6F35 TRANSMISSION—RECREATIONAL TOWING— WITH ALL 4 WHEELS ON THE GROUND—EXPANDED GUIDELINES TO PREVENT TRANSMISSION DAMAGE

TSB 11-7-15

This article supersedes TSB **09-20-13** to update the vehicle model years Service Guidelines.

Figure 1 - Article 11-7-15

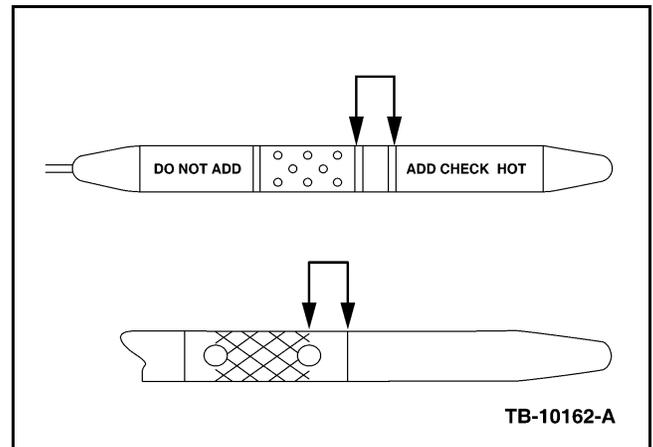
1. Transmission fluid level must be checked at operating temperature of 85 °C - 93 °C (185 °F - 200 °F), per Workshop Manual (WSM), Section 307-01. At this temperature, adjust fluid level to the flat tow area on the dipstick. This level is within the safe operating fluid level and does not require the customer to have the fluid level readjusted after flat tow operation. (Figure 1)

If setting the fluid level for a customer that will be recreational flat towing the vehicle, set the level between minimum line and the minimum hole at the bottom of the hash marks on a blade type dipstick or in the Flat Tow area below the hash marks of the bullet-on-a-wire type dipstick per WSM, Section 307-01. (Figure 1)
